Topic: ENERGY STAR® Water Coolers Draft 1 Version 3 Product Specification

This letter comprises the comments of the Pacific Gas and Electric Company (PG&E), San Diego Gas and Electric (SDG&E), and Southern California Edison (SCE) in response to the United States (U.S.) Environmental Protection Agency (EPA) Draft 1 Version 3 ENERGY STAR® Water Coolers Product Specification.

**Figure 1: Energy use distribution of bottom-load water cooler products.**

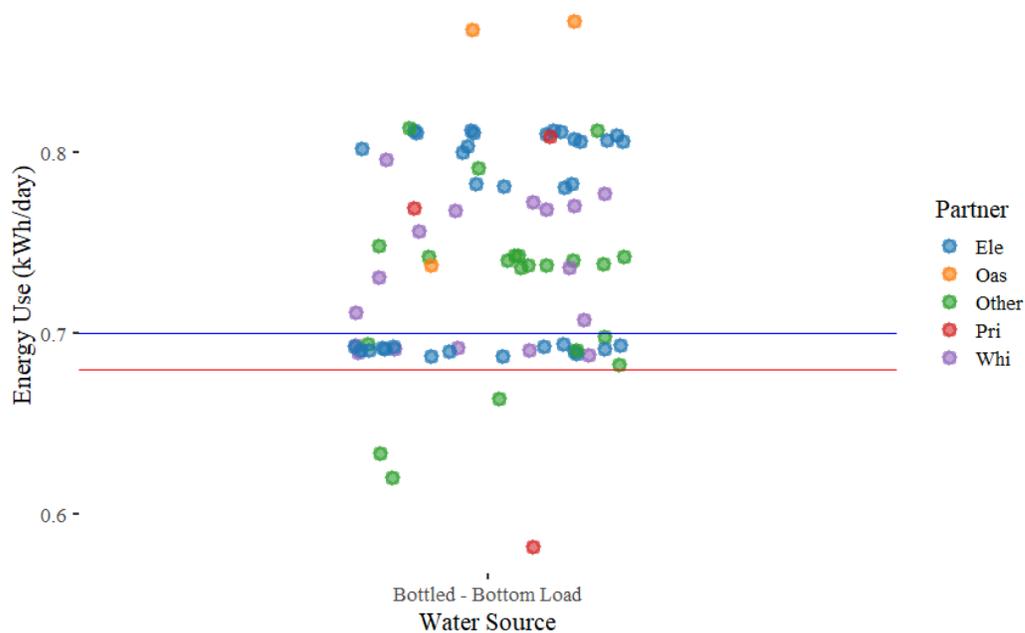
Calculations on the ENERGY STAR Draft 1 dataset indicate that an efficiency requirement level of 0.68 kilowatt-hour (kWh)/day would result in the passing of 39 of 220 ENERGY STAR products, a pass rate of 17 percent. This pass rate plateaus around 0.68 kWh/day, where 0.66 kWh/day still retains 92 percent of those 39 products, indicating sufficient product design and testing tolerance is available at this efficiency requirement level. Closer inspection of the ENERGY STAR dataset indicates that the substantial difference in pass rates between the proposed requirement levels are due to 21 bottom-load models from two manufacturers which have nearly identical product performance. At the proposed 0.68 kWh/day limit, a model from four unique manufacturers would meet the requirement level for bottom-load products. A plot demonstrating the distribution of bottom-load products is shown in Figure 1. Note that the top load category has significant diversity of manufacturers exceeding the requirement levels, see Figure 2 in Appendix A for more details. Note also that *all* conversion type models are eliminated at both the proposed requirement level and the ENERGY STAR Draft 1 requirement level.

Note: Sudden drop-off in pass rates between proposed level and current ENERGY STAR Draft 1 level appear to be caused by an abundance of similar models from Ele. and Whi. in this range. If these products with similar performance were grouped together, these 21 products are effectively two unique models. “Other” manufacturers have two or less Type 3 bottom-load products certified. All four passing bottom-load products are from different manufacturers.

We recommend that EPA recalculate pass rates for products after grouping models from each manufacturer into a single item if the product attributes are similar and performance is identical within two significant figures. We recommend that this result will further corroborate the feasibility

**Figure 2: Product diversity in Type 3, top load category.**  
Source: CA IOUs.

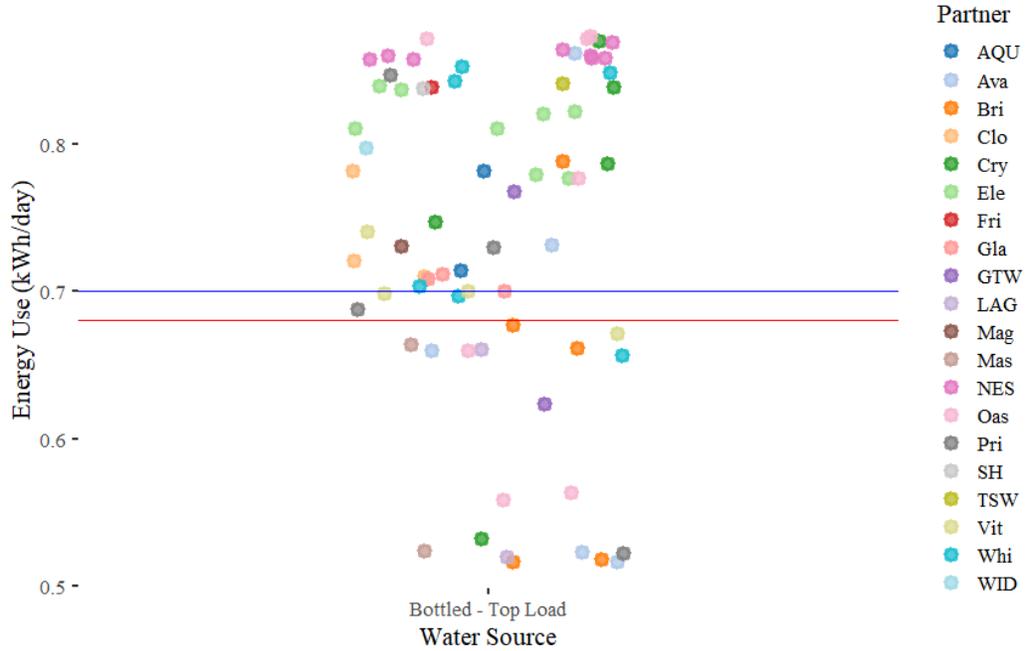
Figure 2 shows that top-load products have good manufacturer diversity below the proposed limit, including a significant group near 0.5 kWh/day. Lines are: Blue – Proposed Energy Star Limit (0.70), Red – Proposed CA IOU Limit (0.68), both values in kWh/day.
